Subject: Final Report – Utility of ATC 145/FEMA P2335 guidelines for New Zealand buildings based on practitioner review

I write in relation to our now completed project, *ATC 145 Guide for repair of earthquake damaged buildings to achieve future resilience* (Contract 3443).

Review of FEMA P-2335 90% Draft

FEMA P-2335 Review

Figure 1: FEMA P2335 flow chart showing process for evaluation of earthquake damage

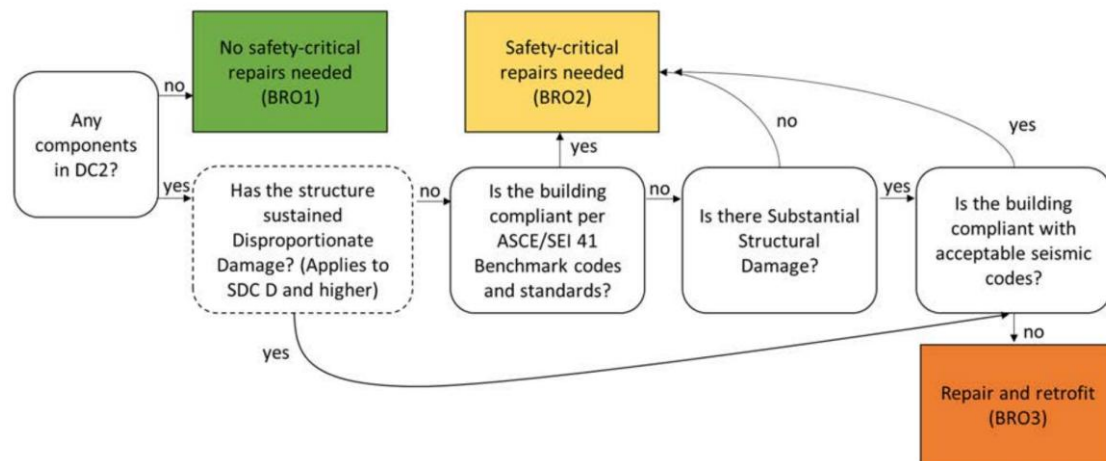
Figure 1 shows an overview of the evaluation procedure described in the guidelines, with “components in DC2” being building elements that have reduced capacity as a result of an earthquake. There are marked differences between the U.S. Building Code framework on which the guidelines are based and the New Zealand Building Code framework. These differences are identifiable even at the high-level represented by Figure 1:

- The U.S. does not have legislative requirements comparable to New Zealand’s earthquake prone building (EPB) regime. The EPB regime means that even a building with no significant structural damage may be required to be retrofitted if a Building Consent is required to complete (non-structural) repairs.
- Additionally, New Zealand does not have an equivalent of “benchmark codes” that are used in the U.S. to deem modern buildings to have sufficient capacity without further calculation.

Both of these points of difference would result in more engineering effort being required to apply the guidelines under current legislative settings in New Zealand.

Figure 1 Building assessment process and subsequent actions when an area has been designated for building emergency management - except simple residential buildings (MBIE, 2020).

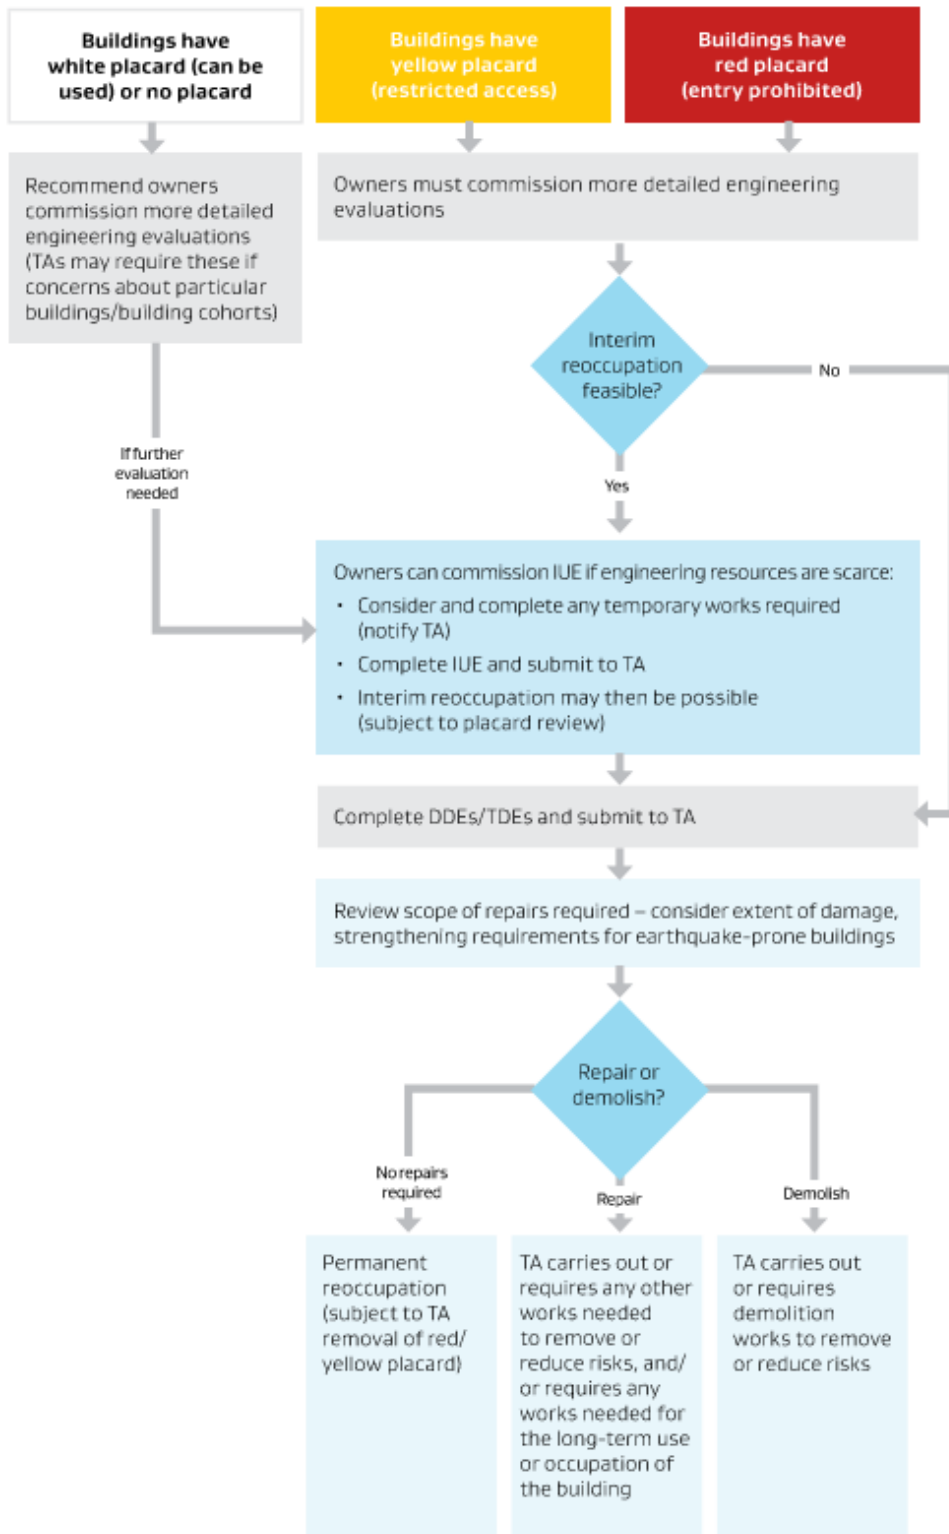
Figure 1 below from MBIE (2020) summarises the recommended assessment process for non-residential buildings an area has been designated for building emergency management. The process makes reference to the following three post-earthquake evaluations:

- Interim Use Evaluation (IUE)
- Detailed Damage Evaluation (DDE) – developed in response to the 2011 Canterbury earthquake
- Target Damage Evaluation (TDE) – developed in response to the 2016 Kaikoura earthquake.

The TDE is similar to the FEMA P-2335 Preliminary Inspection and the DDE is similar to the FEMA P-2335 Detailed Inspection. It follows then FEMA P-2335 could be used to inform and update the existing DDE and TDE procedures.
